INDESIT company

Model type:
AVF169SK

Commercial code:
F033980

Fig . 001

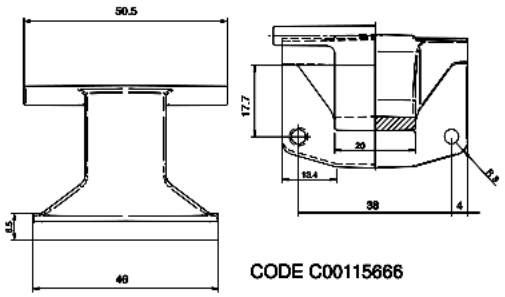
n1040349: Introduction of 150° Zamac hinge on Ariston 46 models.

From serial no. 50207.0001, all Ariston models produced in the Teverola factory (see table 001 attached) with industrial code (given on the rating plate) starting with 46, have been equipped with a Zamac hinge with 150° opening angle, code C00115666

(see Fig.001).
This modification has involved the introduction of the following items:

Code C00115670 - Complete door EVOII 150° white 27 with standard glass;
Code C00115674 - Complete door EVOII 150° white 27 with long glass;
Code C00115667 - EVOII body for 150° hinge white 27;

The premodified items are not interchangeable separately with the modified ones.

Code C00110133 - Complete door EVOII Standard 180° white 27 standard glass;
Code C00092157 - Complete door EVOII 180° white 27 long glass;
Code C00096193 - EVOII body for 150° hinge white 27;

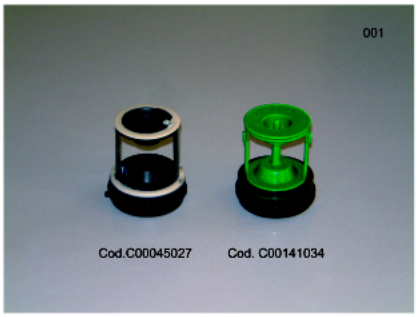
n1040376: Drain pump with filter with pin.

A new drain pump with filter with pin has been introduced progressively as from serial no. 50609.0001.

New parts:
C00119307 - Drain pump with pin filter;
C00141034 - Askoll / Plaset drain pump with pin filter kit (figure 001);

Premodification parts:
C00092264 - Drain pump;
C00045027 - Askoll / Plaset pump filter kit (figure 001);

The new parts can be used on all WASHING MACHINES previously equipped with the premodification parts.
